Entergy Nuclear Generation Co.
Pilgrim Nuclear Power Station
600 Rocky Hill Road
Plymouth, MA 02360

September 1, 2000
ENGC Ltr. 2.00.039

REQUEST FOR TECHNICAL SPECIFICATION CHANGE
CONCERNING VESSEL MATERIAL SURVEILLANCE INTERVAL (CAPSULE PULL)

Pilgrim Fluence vs EFPY
(GE vs SWRI Comparison)
1.0E+19
1.0E+18
1.0E+17
Fluence
10.0
RFO12
EOL
100.0
EFPY
SWRI Plate ID
GE Plate ID
SWRi Capsule/Weld ID
GE Capsule/Weld ID
Fluence

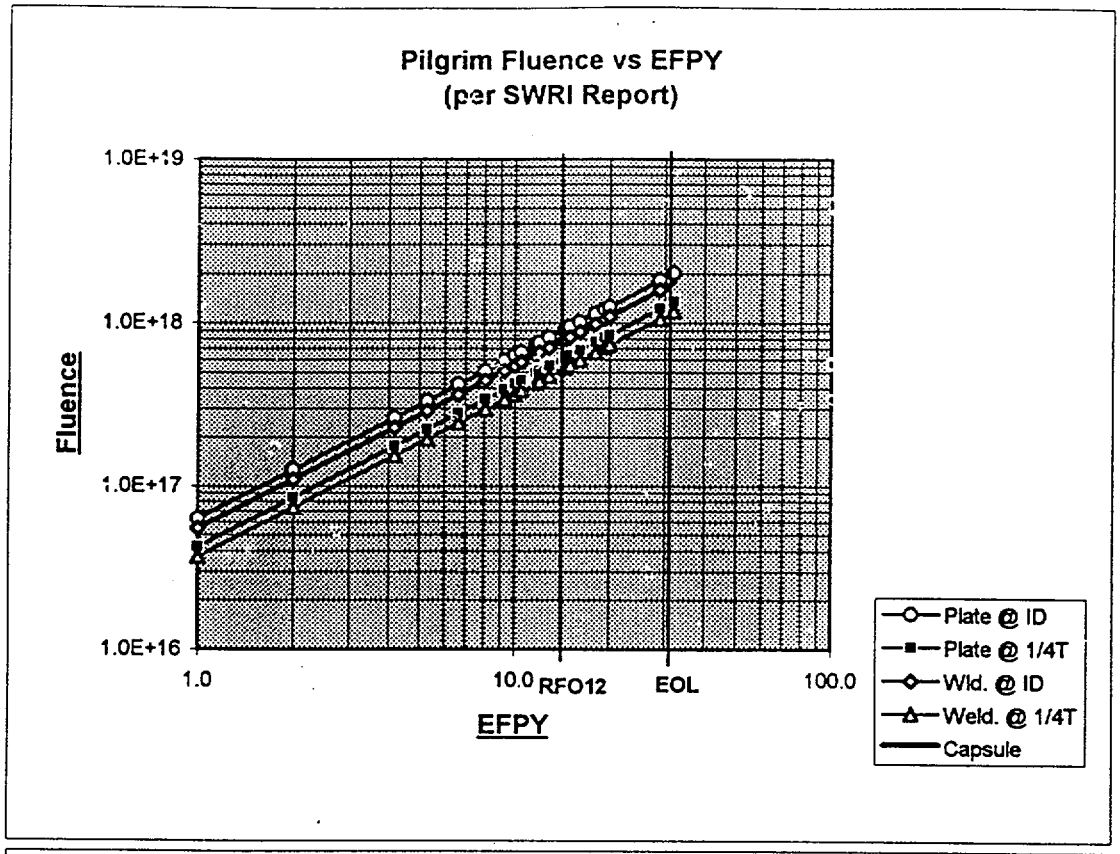
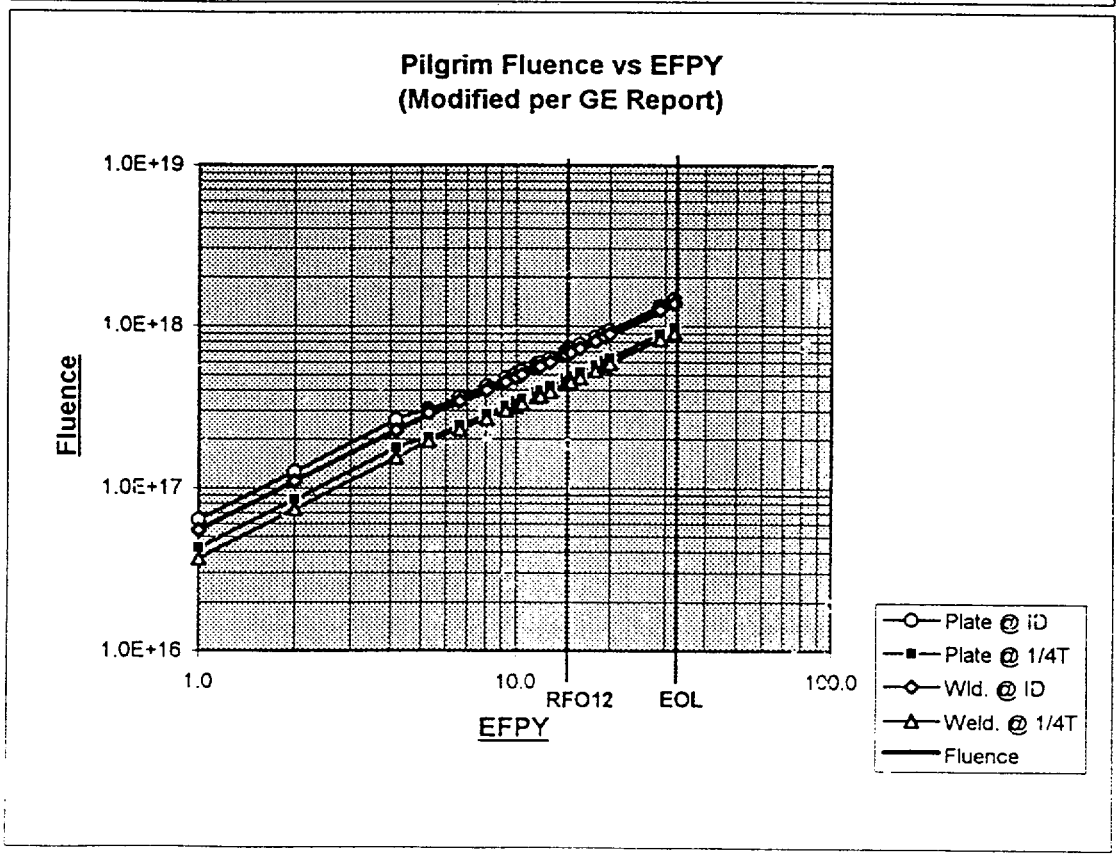
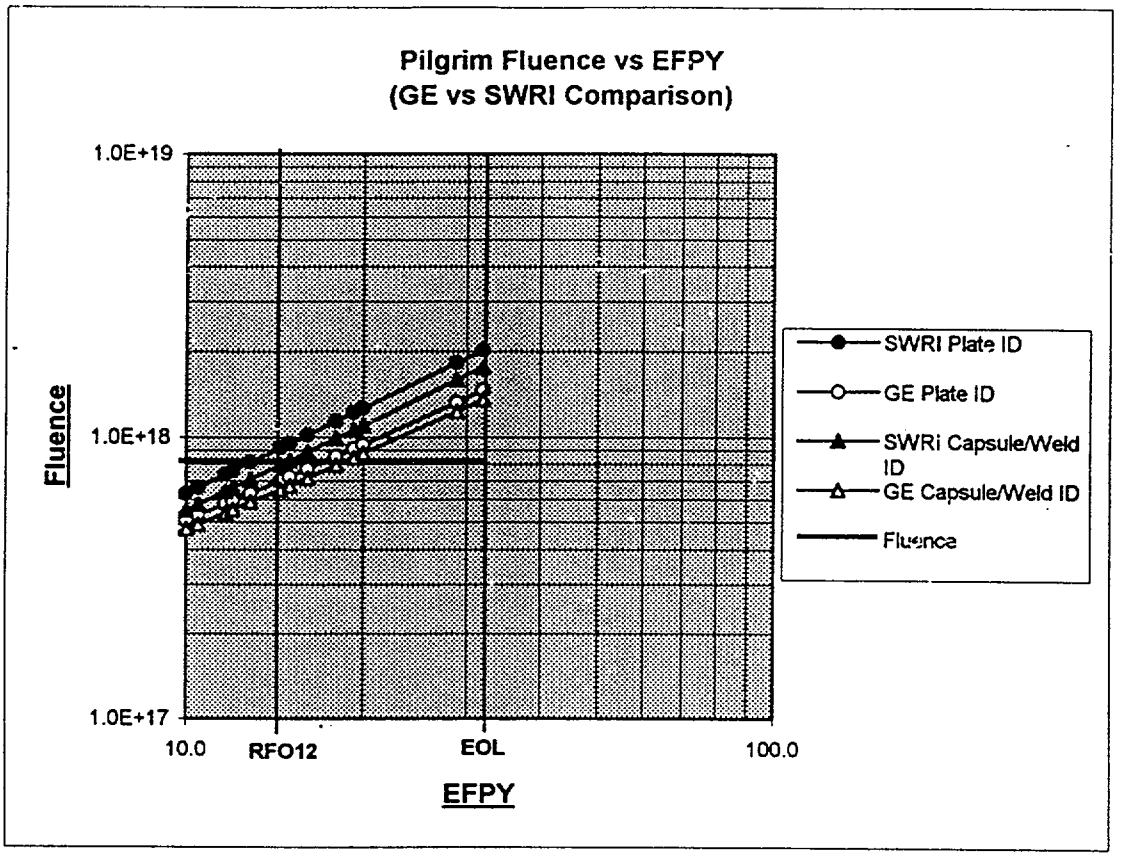
The capsule fluence (from the SWRI report) forms the basis for the Tech. Spec Ammendment withdrawal schedule. However, fluence values based on service time were significantly reduced per the GE Neutron Transport Analysis. Consequently, the fluence based on the GE analysis at 19.23 EFPY would be comparable to the 15 EFPY fluence based on the SWRI report.
